World Forum for Harmonization of Vehicle Regulations**Working Party on Noise and Tyres****Seventy-fifth session**

UN Regulation No. 51 (Noise of M and N categories of vehicles)**Amendment to Working Document GRBP/2022/3 proposed
by the experts at the 17th Session.****Proposal for Supplement 10 to the 03 series of amendments
to UN Regulation No. 51****Submitted by the Informal Working Group on Additional Sound
Emission Provisions***

The text reproduced below was prepared by the experts from the Informal Working Group on Additional Sound Emission Provisions (IWG ASEP) in order to improve the current wording for better clarification. The proposed changes are based on the 03 series of amendment to UN Regulation No. 51 up to Supplement 6. The modifications are marked in bold for new or strikethrough for deleted characters.

Flowchart for vehicles tested according to paragraph 3.1.2.1. of Annex 3 to this Regulation - Gear selection using locked gear PART 1

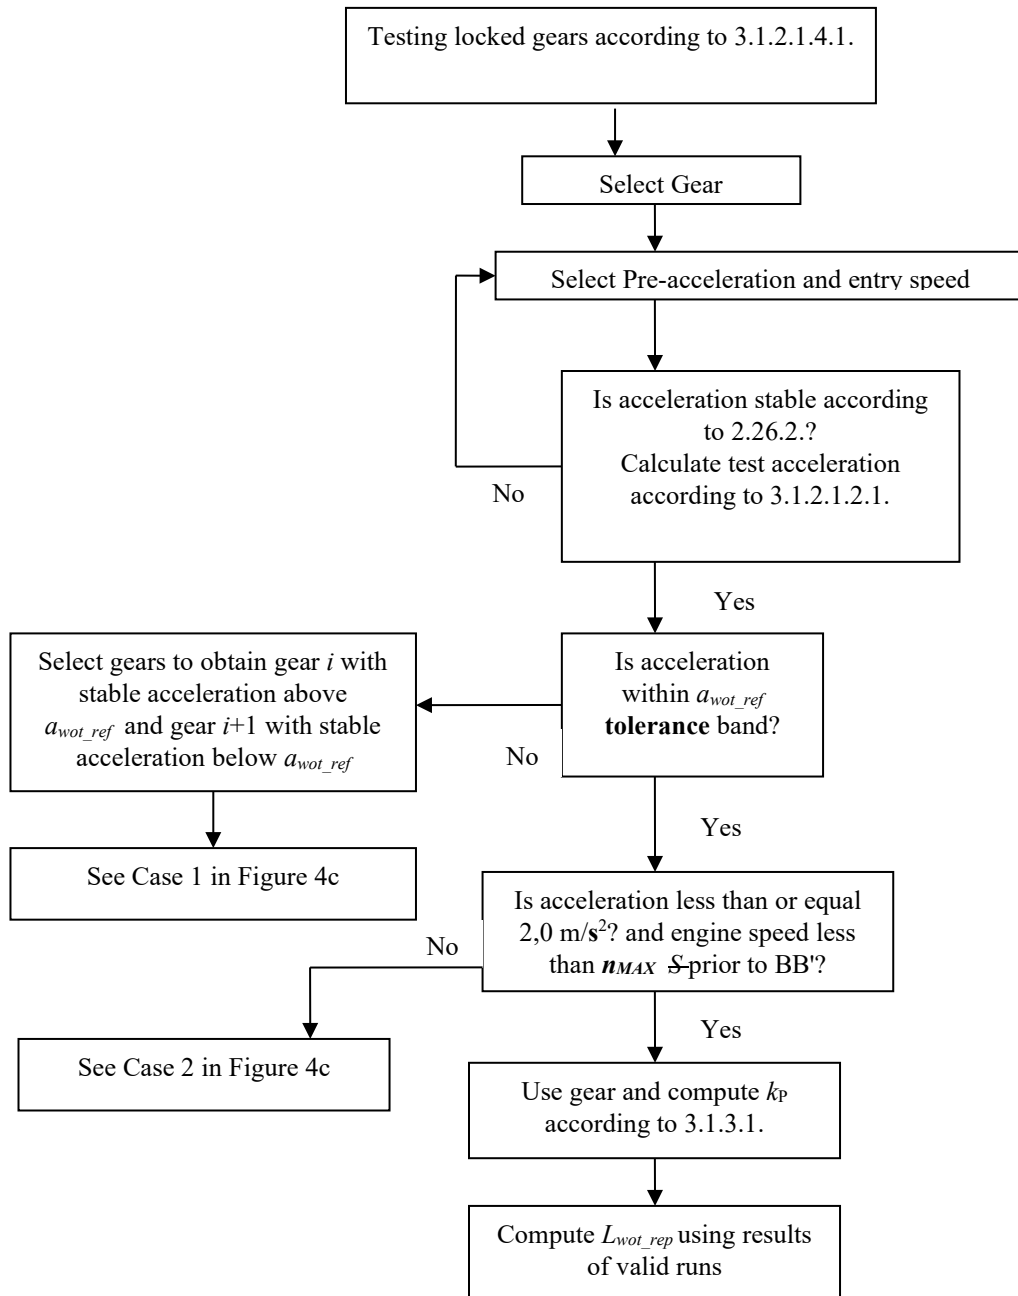
Annex 3 - Appendix, Figure 4b, amend to read:

13. Annex 3, figures 4b to 4f have been updated according to the introduction of n_{MAX} mentioned above.

"Figure 4c
**Flowchart for vehicles tested according to paragraph 3.1.2.1. of Annex 3 to this Regulation –
 Gear selection using locked gear PART 2**

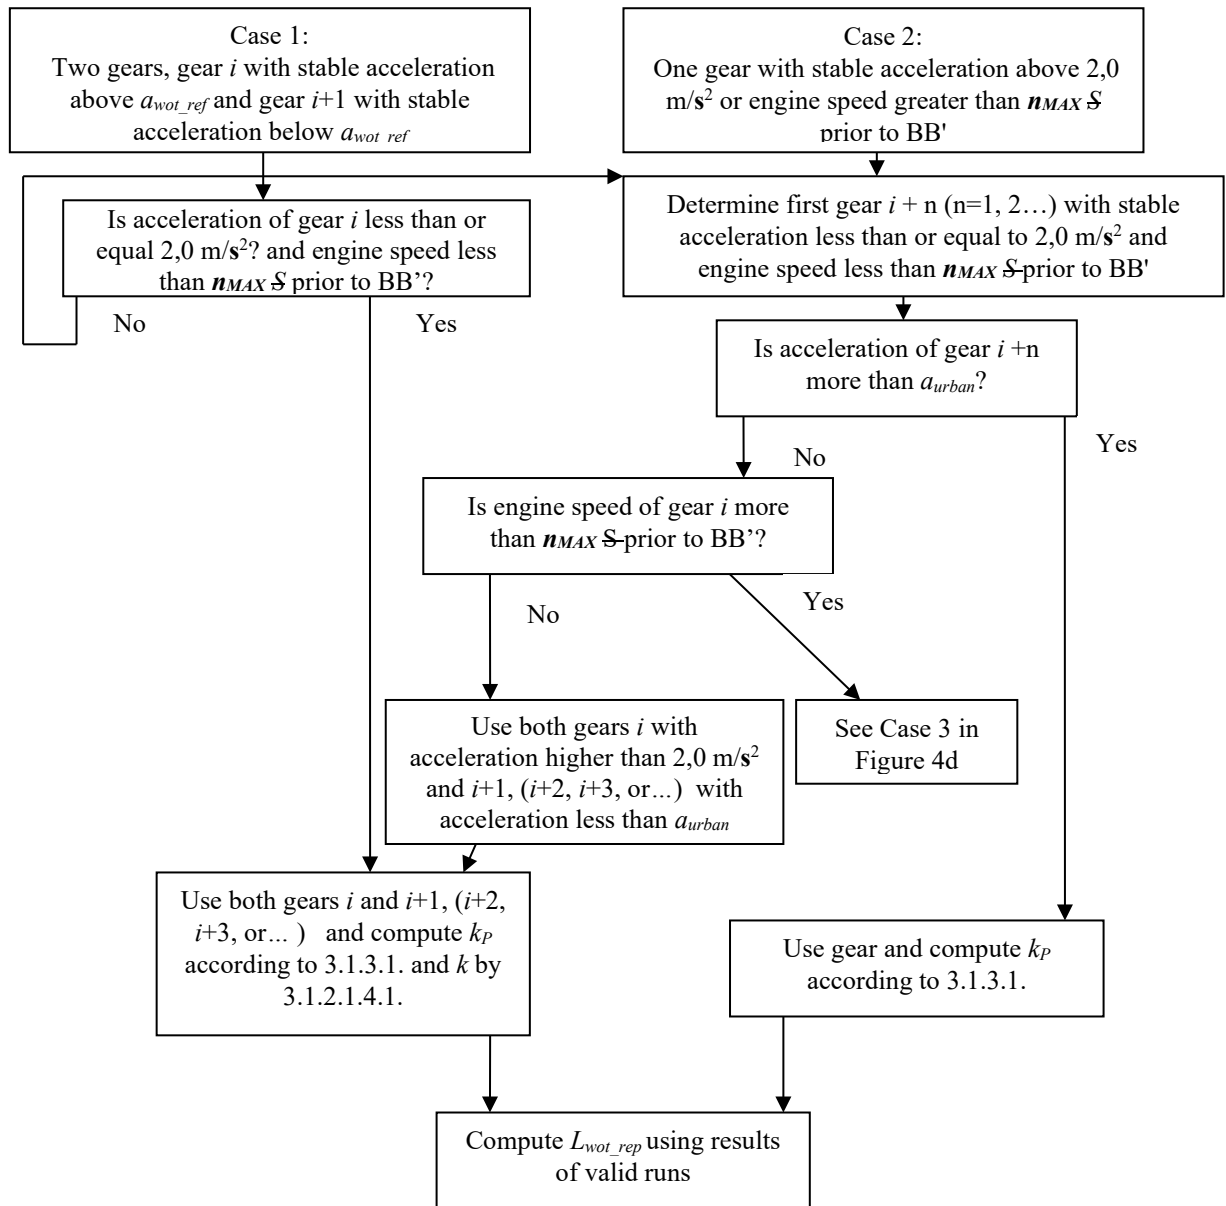
Annex 3 - Appendix, Figure 4c, amend to read:

**Flowchart for vehicles tested according to paragraph 3.1.2.1. of Annex 3 to this Regulation –
Gear selection using locked gear PART 3**

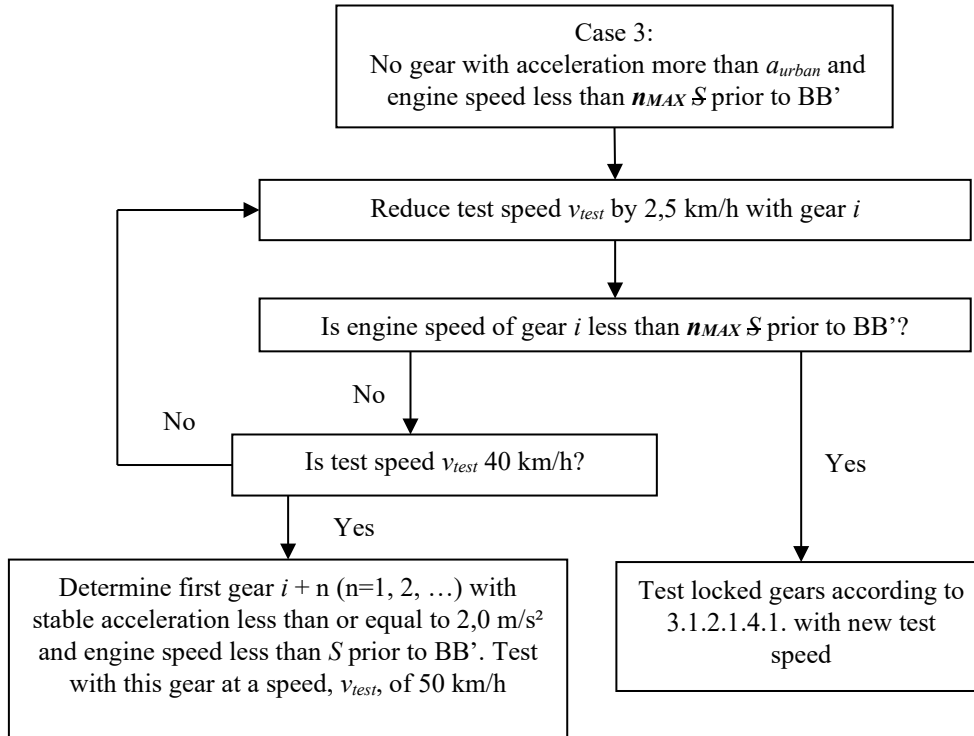
Annex 3 - Appendix, Figure 4d, amend to read:

"Figure 4e
**Flowchart for vehicles tested according to paragraph 3.1.2.1. of Annex 3 to this Regulation –
 Gear Selection using non-locked gears**

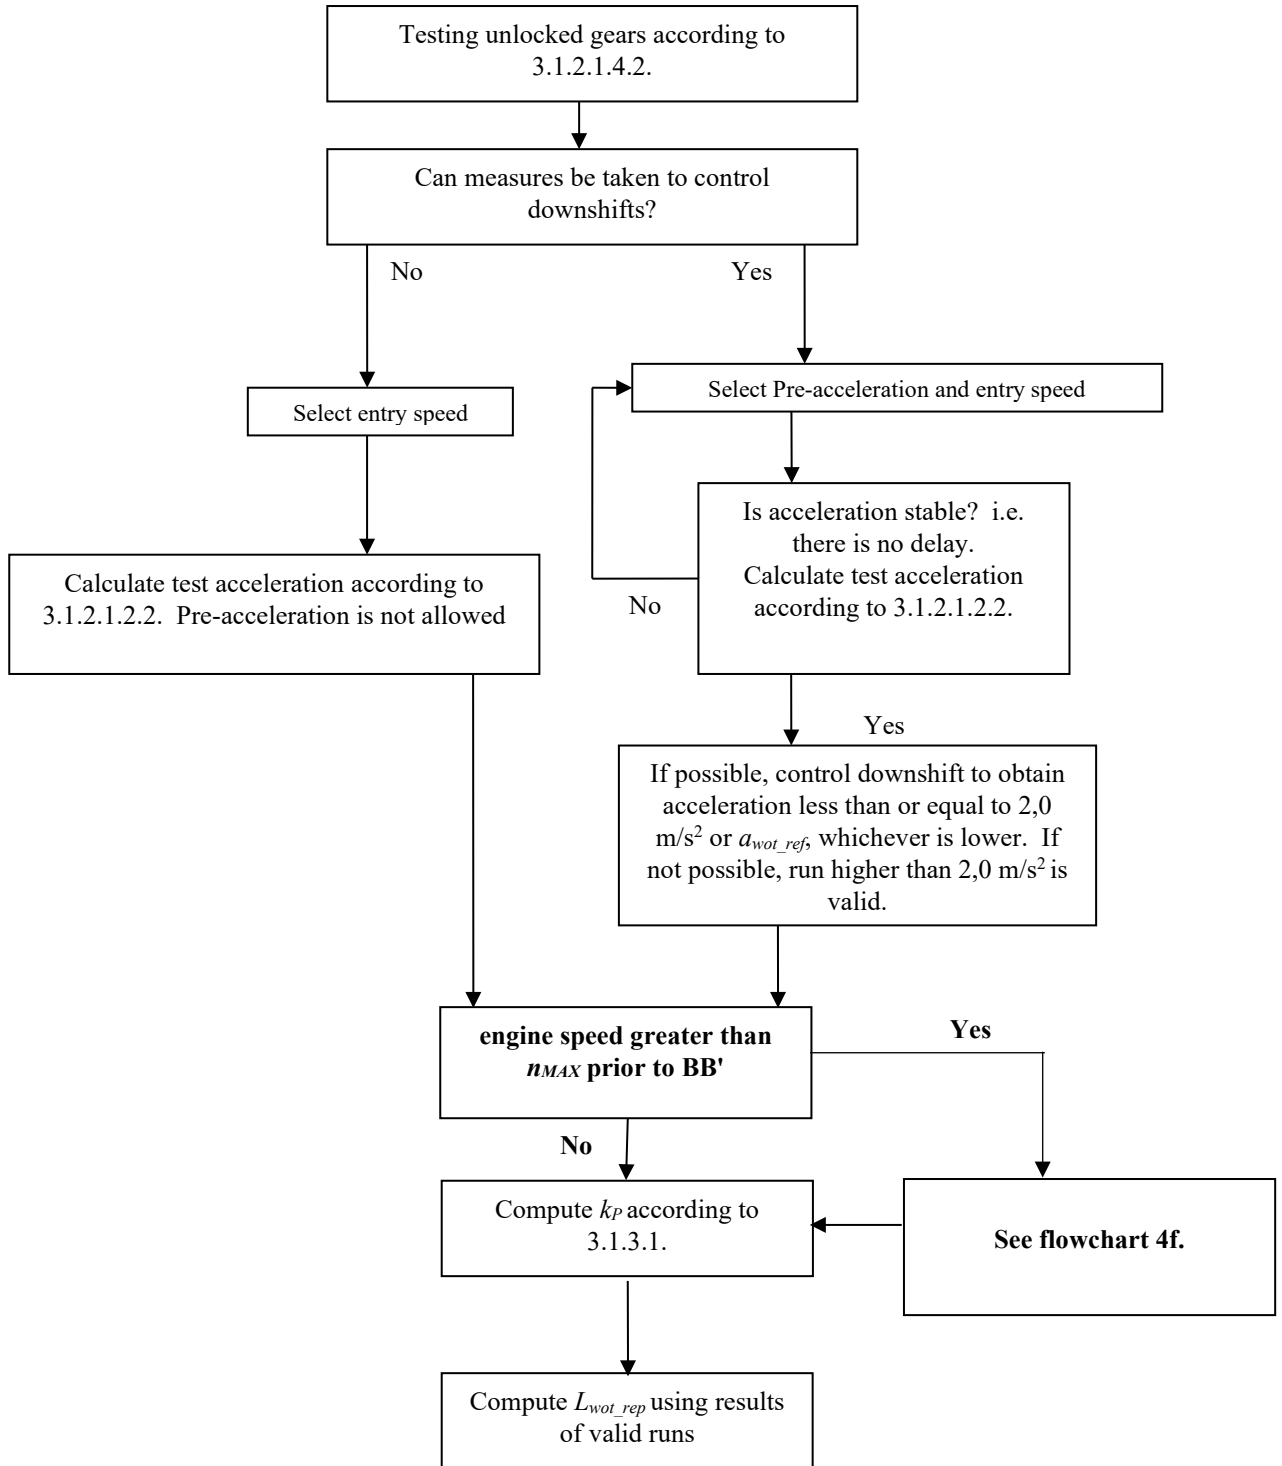
Annex 3 - Appendix, Figure 4e, amend to read:

Flowchart for vehicles tested according to paragraph 3.1.2.1.4.2. of Annex 3 to this Regulation – Gear Selection using non-locked gears

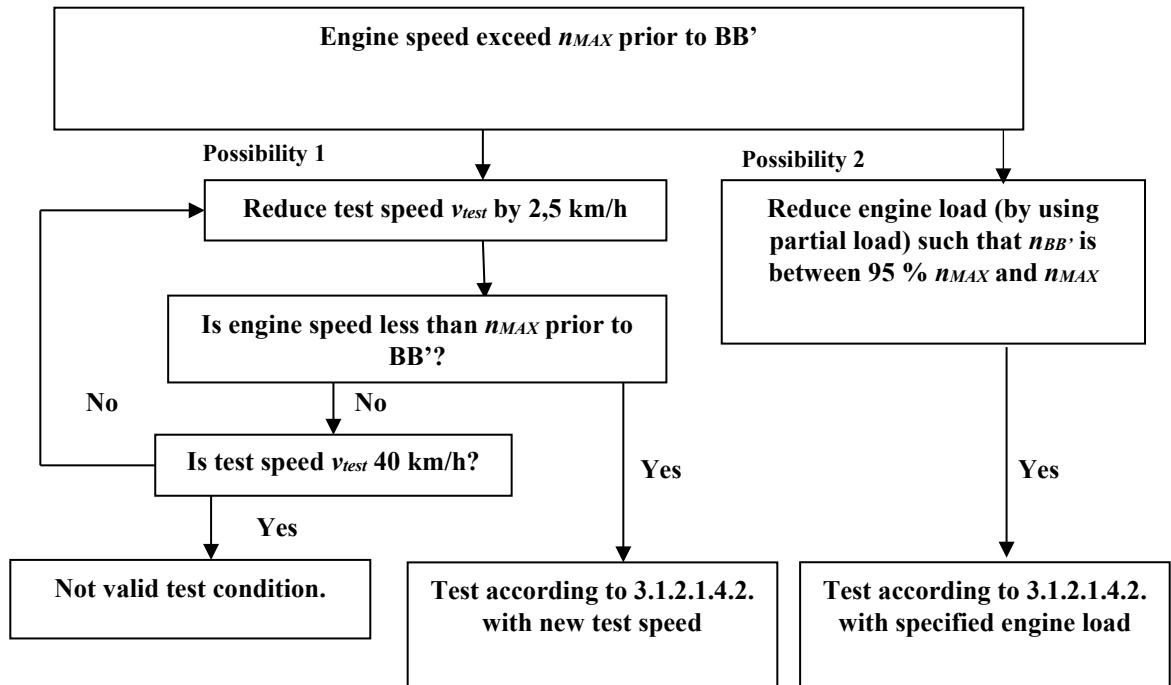
- (a) **accelerations beyond 2.0 m/s². Any measure used by manufacturer for the above-mentioned purposes shall be documented in the test report.** The achieved acceleration a_{wot_test} shall be greater or equal to a_{urban} .
- (b) **a test engine speed exceeding n_{MAX} (see Appendix 1, figure 4f).**
- (i) **Therefore, the vehicle test speed v_{test} may be reduced in steps by 2.5 km/h. In no case the vehicle test speed shall be reduced to a vehicle speed below 40 km/h, or**
- (ii) **The engine load is reduced to avoid a downshift to a gear ratio where n_{MAX} is exceeded.**

Annex 3 - Appendix, add a new Figure 4f, to read:
